PLANT NAME: Cook #1

Effects of burnup on allowable peaking factor
during Cycle 2 operation.....

Donald C. Cook Nuclear Plant Unit 1
Docket No. 50-315
DPR No. 58

FIGURE 3.2.3 $E(t)$ NORMALIZED CORE POWER AS A
FUNCTION OF CYCLE BURNUP

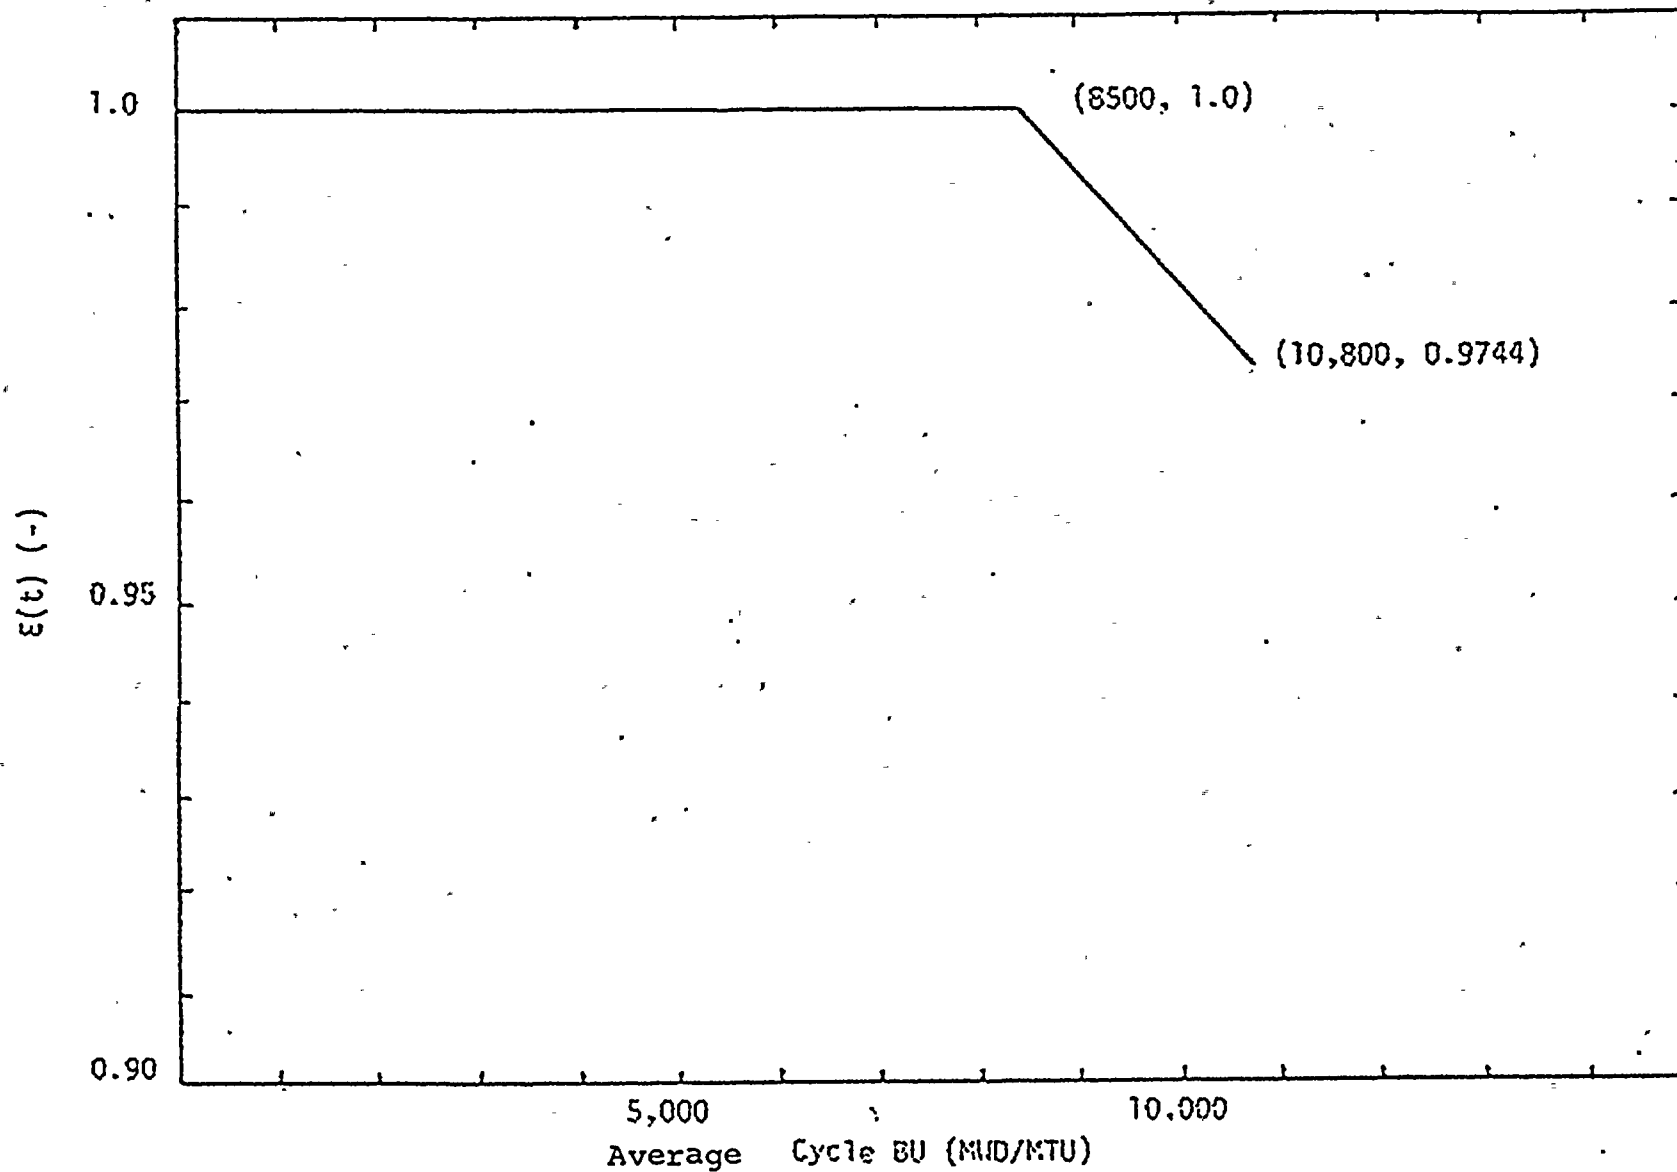
This letter transmits information required by the NRC Staff in Revision 1 to the Safety Evaluation Report (SER) dated January 5, 1977 (Reference 1) concerning the effect of burnup on allowable peaking factor (F_Q). The SER revision required that we modify the allowable peaking factor of 1.95 for Cycle 2 operation which was calculated in accordance with the provisions of 10 CFR Part 50 using the Exxon Nuclear Corporation WREM-II Evaluation Model (References 2,3, and 4) using methods specified in the SER revision. These methods specified the manner in which rupture pin pressure uncertainties are to be accounted for in the analysis.

The NRC staff also requested verbally that we determine the time during Cycle 2 that the value of F_Q would drop below 1.95 when the above uncertainties were taken into account. Such a calculation was performed and it was determined that F_Q would not drop below 1.95 until the pin rupture exceeded 667 psid (differential pressure). This will occur at a point in time corresponding to 80% of the first cycle; i.e., at an average cycle burnup of 8500 MWD/MTU (peak pellet burnup of 12,000 MWD/MTU).

This burnup dependence may be applied to the Donald C. Cook Nuclear Plant by applying a multiplier on F_Q as a function of cycle life. This multiplier is shown on the attached curve, showing no multiplier is required to be applied to the 1.95 peaking factor until a burnup of 8500 MWD/MTU has been reached, and then showing the multiplier to vary linearly between 1.0 and 0.9744, between 8500 and 10,800 MWD/MTU average cycle burnups; which when applied to the 1.95 peaking factor, yields a peaking factor of 1.90 at expected end-of-life.
